# RENESAS TECHNICAL UPDATE

Product Category	MPU & MCU	Document No.	TN-16C-A206A/E	Rev.	1.00
Title	Errata to R32C/120 Group Hardware Manual		Information Category	Technical Notification	
Applicable Product	R32C/120 Group	Lot No.	Reference Document	R32C/120 Group Hardware Manual Rev. 1.10 (REJ09B0476-0110)

This document describes corrections to the R32C/120 Group Hardware Manual, Rev. 1.10.  
The corrections are indicated in red in the list below.

Figure 7.1 Clock Generation Circuitry

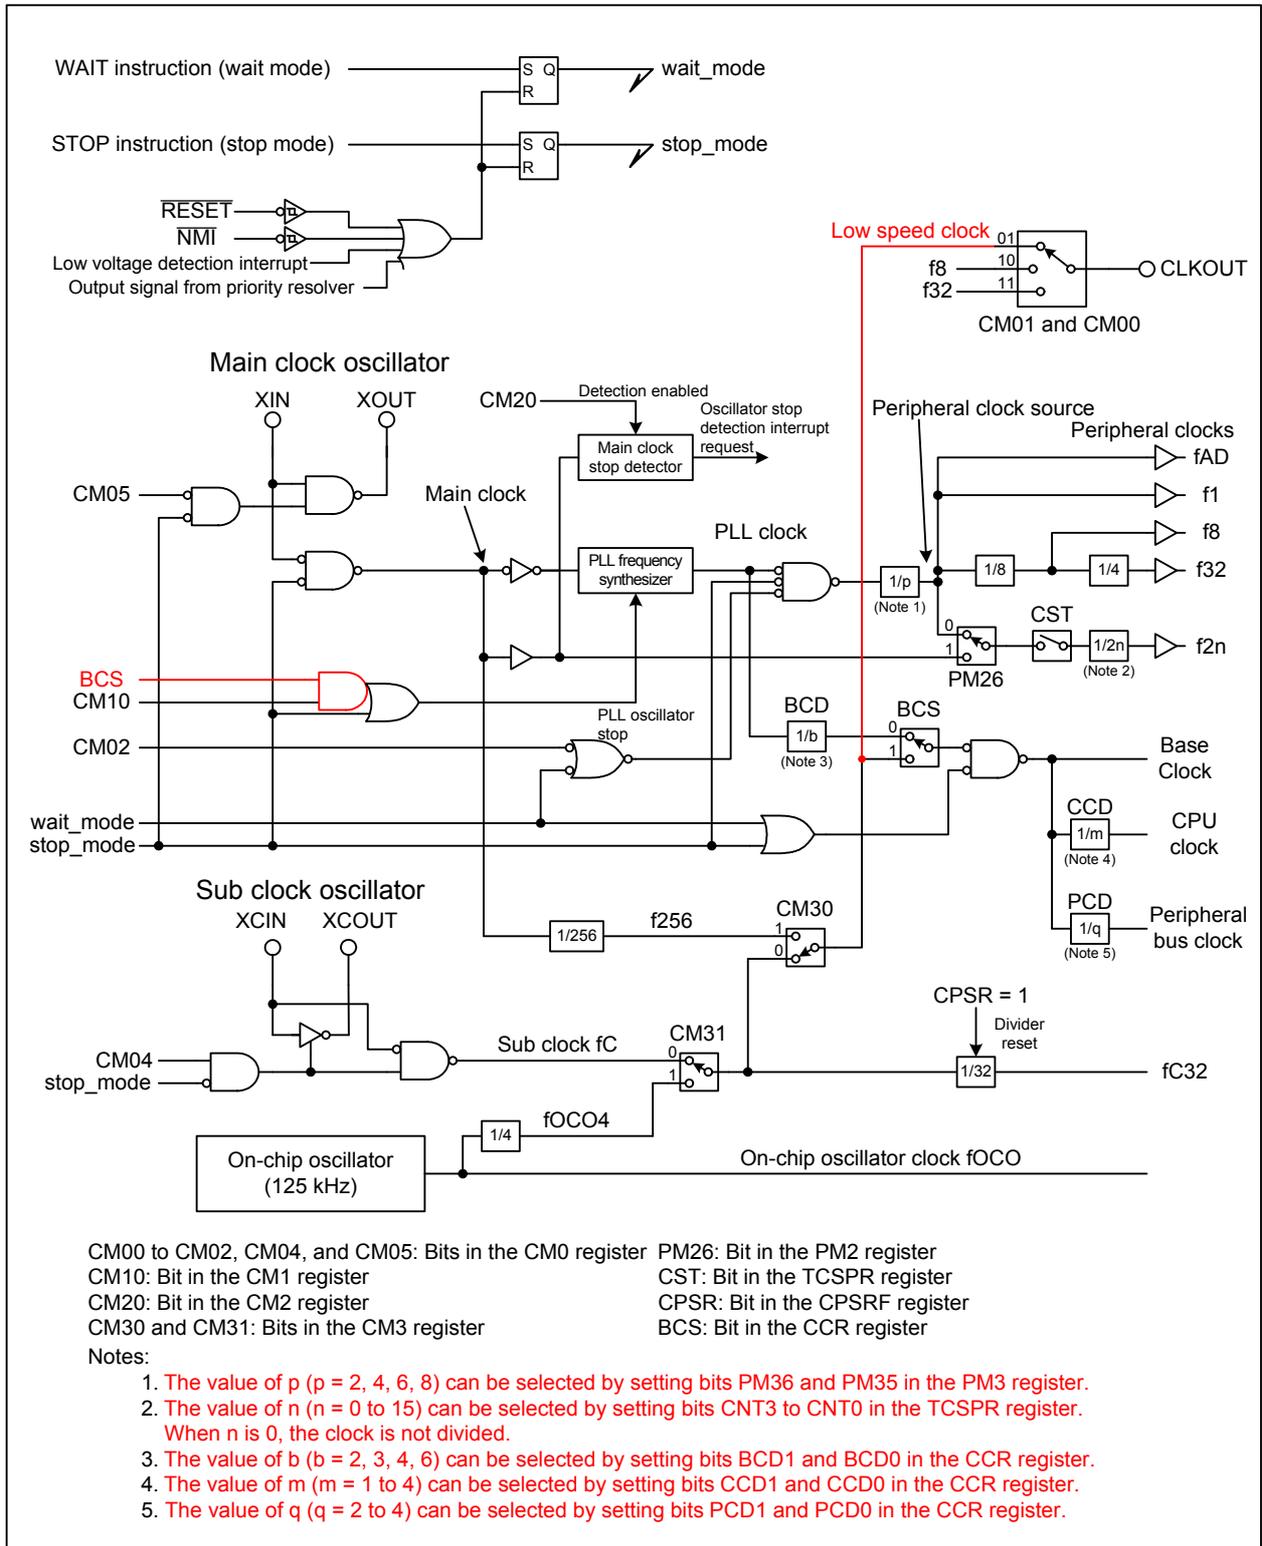
•Page 72 of 588, Figure 7.1 is corrected as follows:

**Figure 10.8 Priority Resolver**

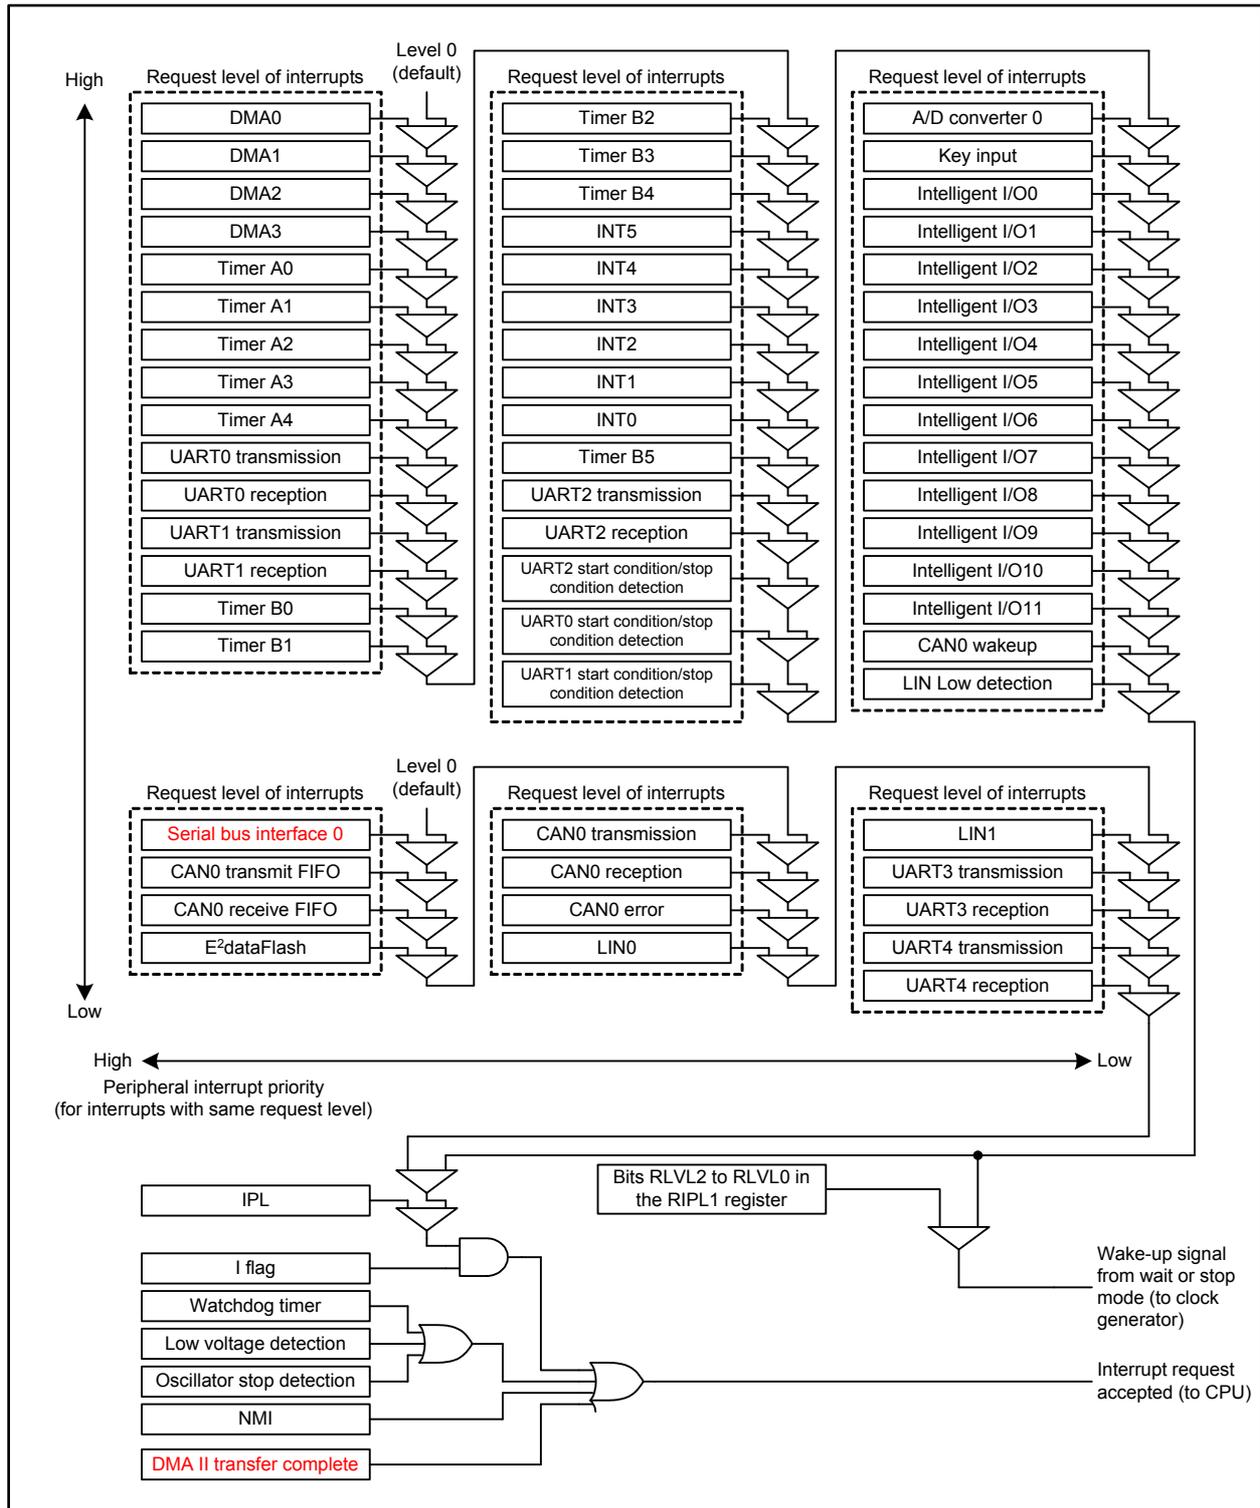
•Page 124 of 588, Figure 10.8 is corrected as follows:

(Description “Bits RLV2 to RLV0 in the RIPL2 register” and associated signal lines are deleted from Figure 10.8)

Figure 20.1 CRC Calculator Block Diagram

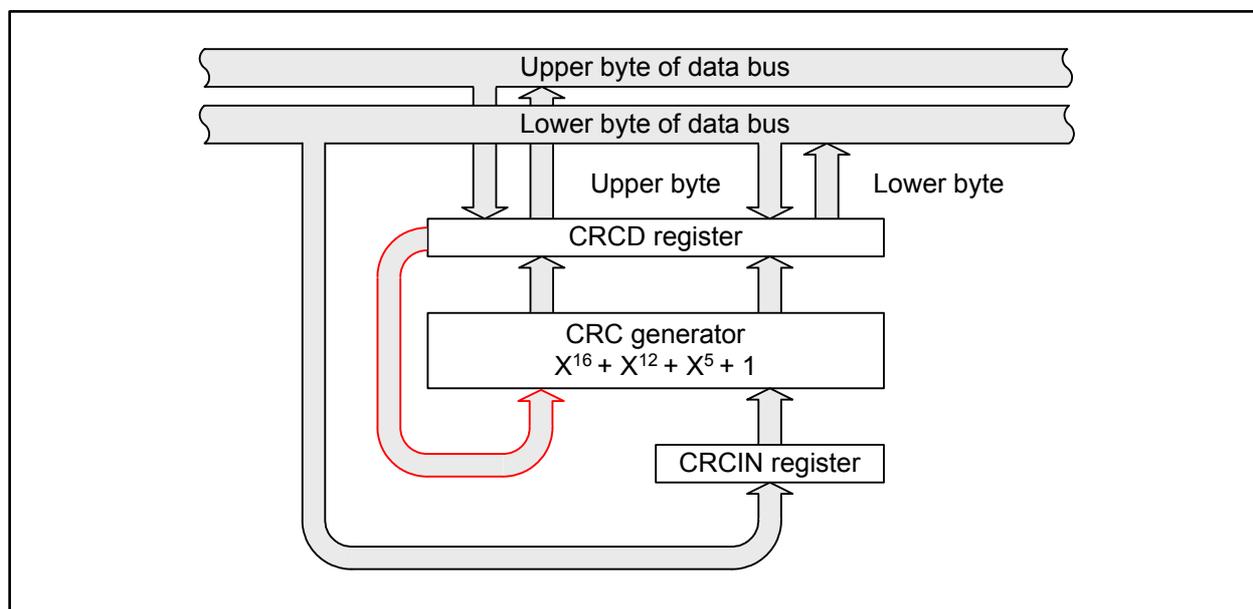
- Page 289 of 588, Figure 20.1 is corrected as follows:

**Figure 24.30 Example of Setting Before Transition to Wait Mode**

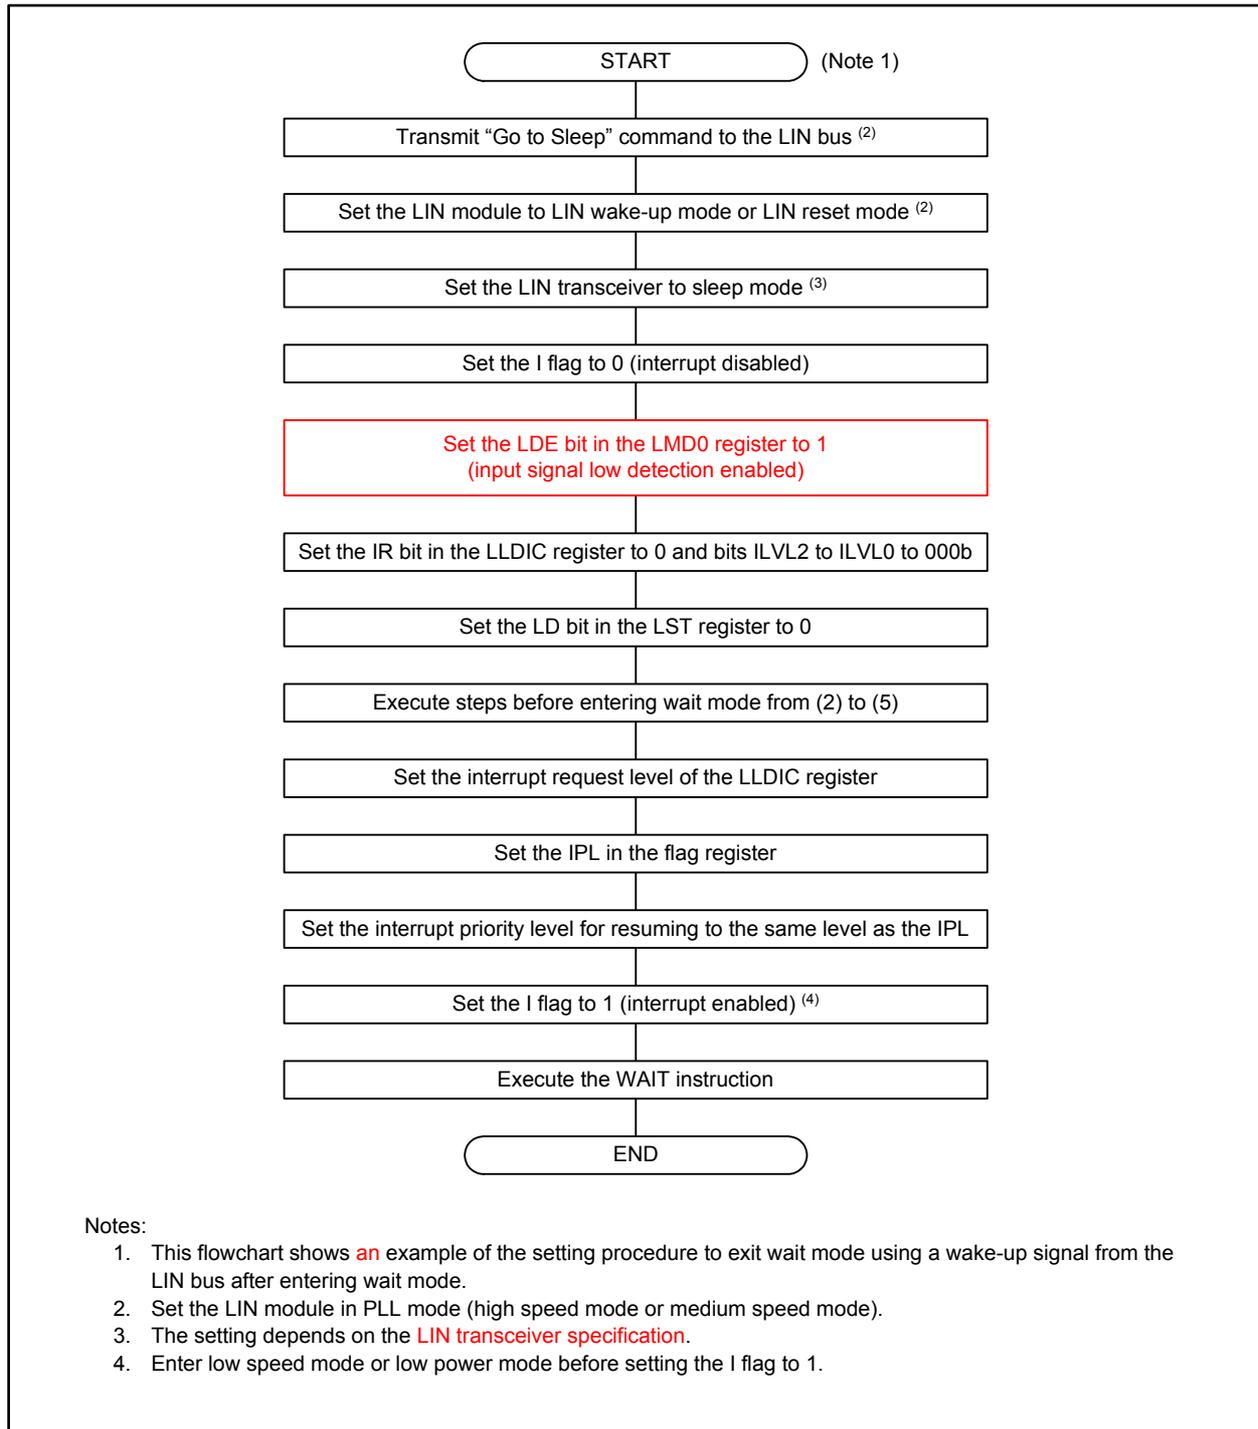
•Page 394 of 588, Figure 24.30 is corrected as follows:

Figure 24.32 LINj Interrupt Block Diagram (j = 0, 1)

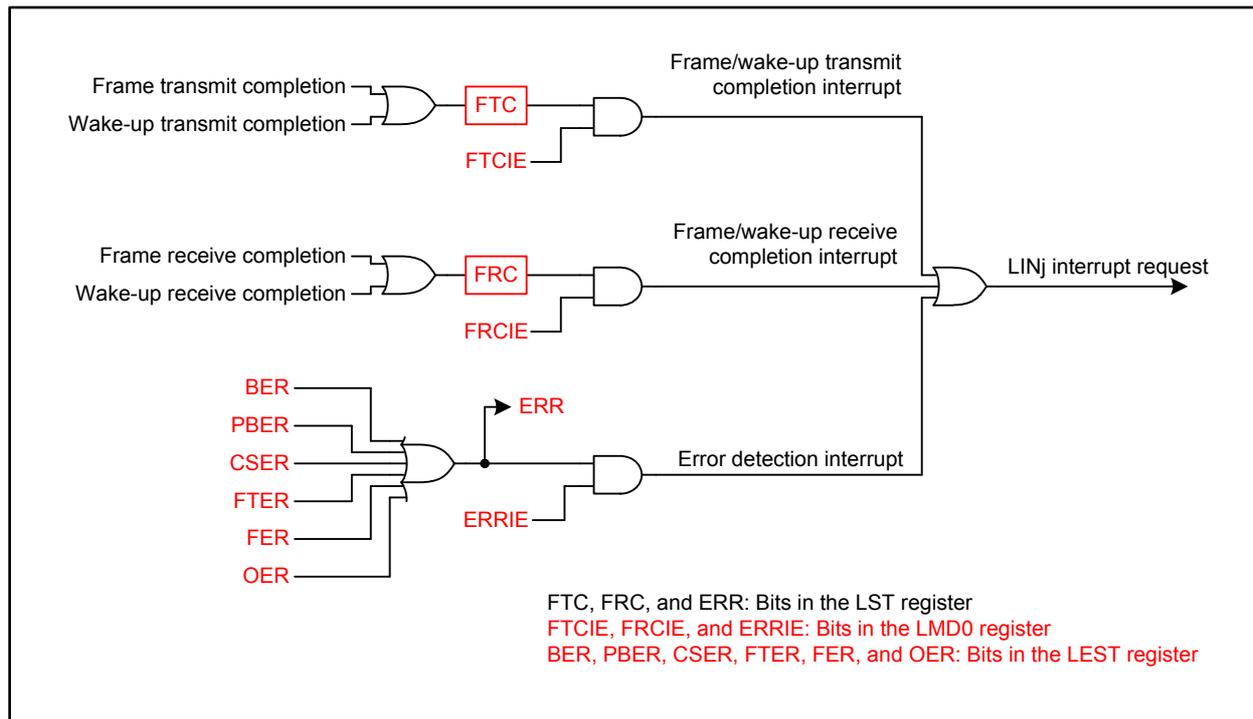
•Page 398 of 588, Figure 24.32 is corrected as follows:

Figure 24.33 LIN Low Detection Interrupt Block Diagram

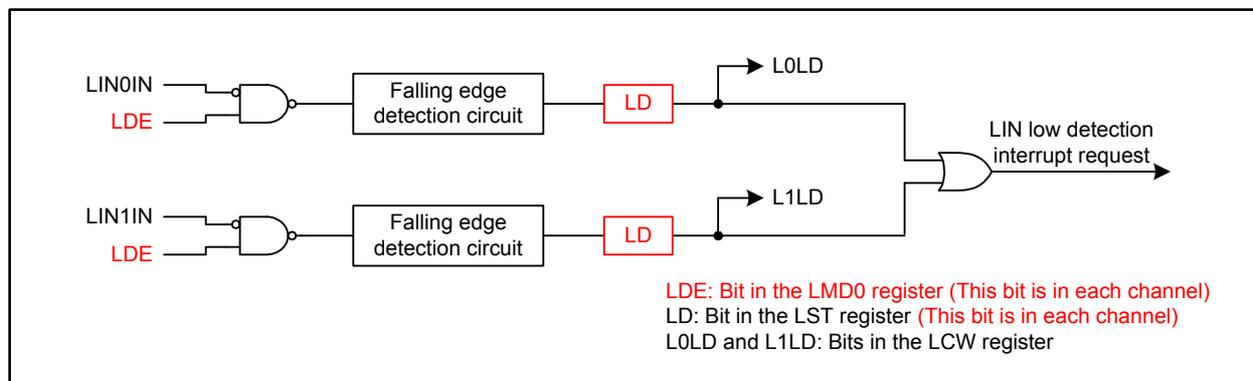
•Page 398 of 588, Figure 24.33 is corrected as follows:

**Figure 26.1 Typical I/O Pin Block Diagram (i = 0 to 10; j = 0 to 7)**

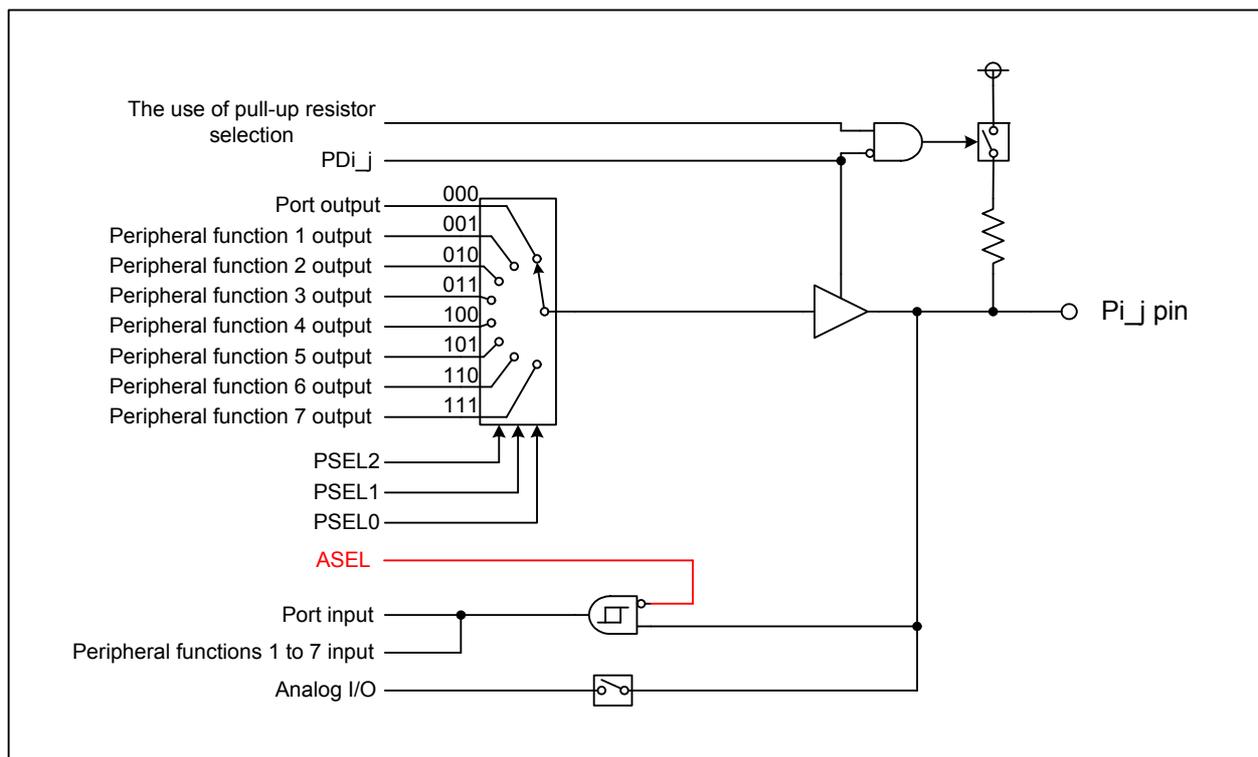
- Page 468 of 588, Figure 26.1 is corrected as follows (refer to TN\_16C\_A198A/E):

Figure 27.2 Addresses for ID Code Stored

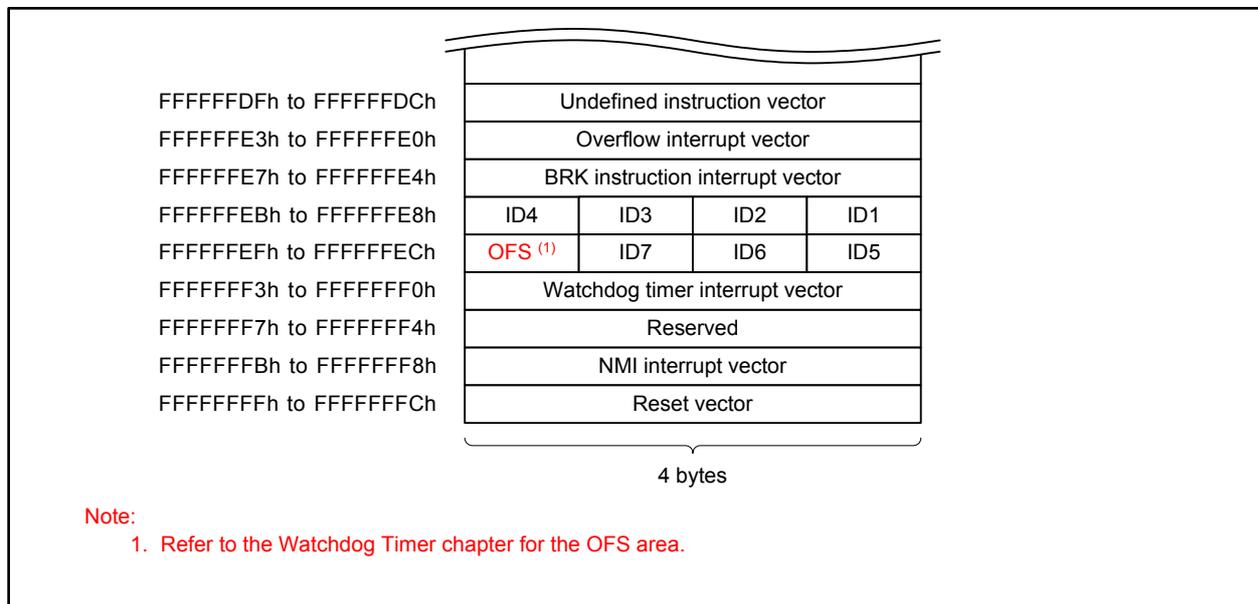
- Page 493 of 588, description “use the serial programmer to” is deleted from line 3 of 27.2.2.
- Page 494 of 588, Figure 27.2 is corrected as follows:

Figure 27.12 Read Timing

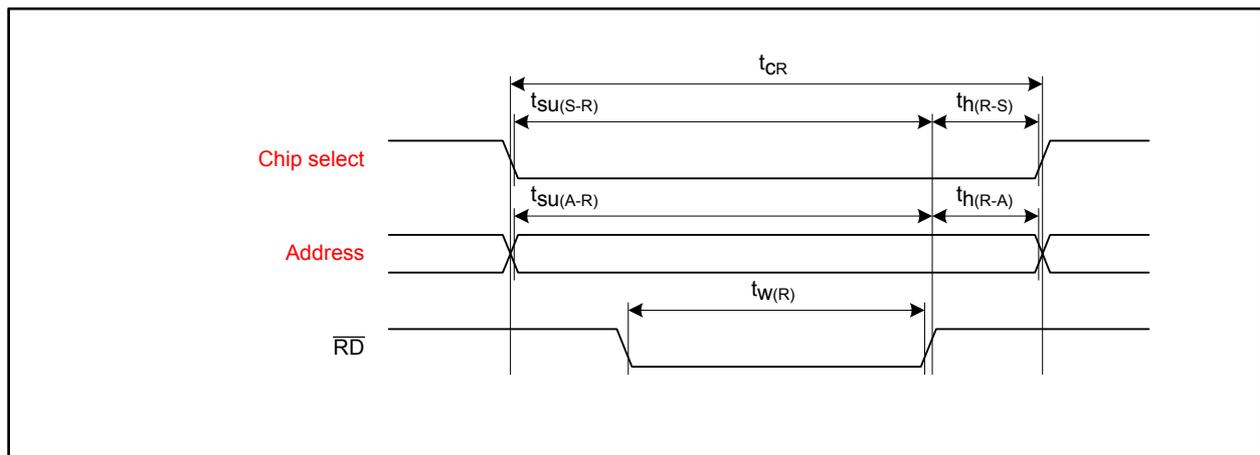
•Pages 502 and 504 of 588, descriptions in Figures 27.12 and 27.13 are corrected as follows:

Figure 29.5 Flash Memory CPU Rewrite Mode Timing

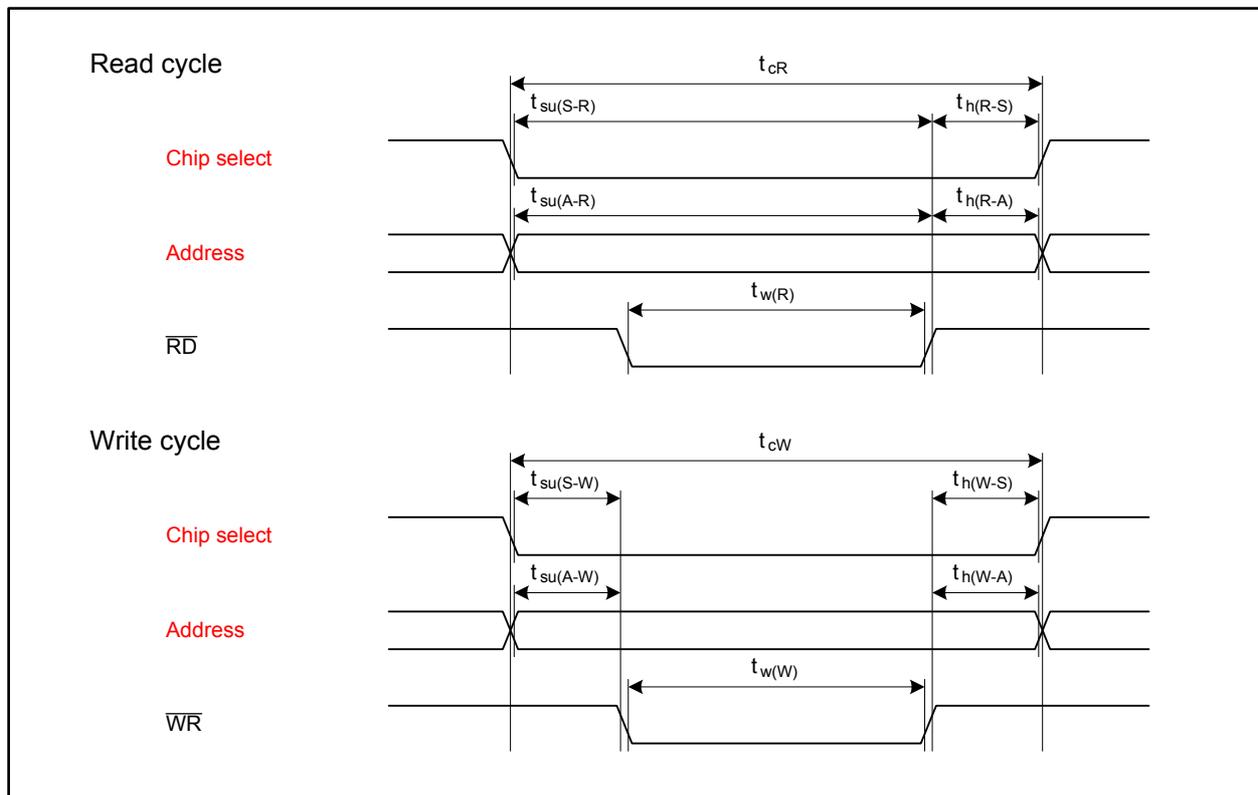
- Page 522 of 588, the following description is added to Note 3 of Figure 28.2:  
 “However, the registers are not initialized.”
- Page 522 of 588, description “This mode setting prevents data from being overwritten if a program goes out of control.” is deleted from Note 5 in Figure 28.2.
- Page 528 of 588, description “EERR bit in the E2FS0 register is 1?” in Figure 28.12 is corrected as follows:  
 “EERR bit in the E2FS0 register is 0?”
- Pages 537 and 538 of 588, description “Programming and erasure endurance of flash memory” in Tables 29.8 and 29.9 is changed as follows:  
 “Program and erase cycles”
- Pages 537 and 538 of 588, unit “times” for “Programming and erasure endurance of flash memory” in Tables 29.8 and 29.9 and Note 1 is corrected as follows:  
 “Cycles”
- Page 541 of 588, descriptions in Figure 29.5 are corrected as follows:
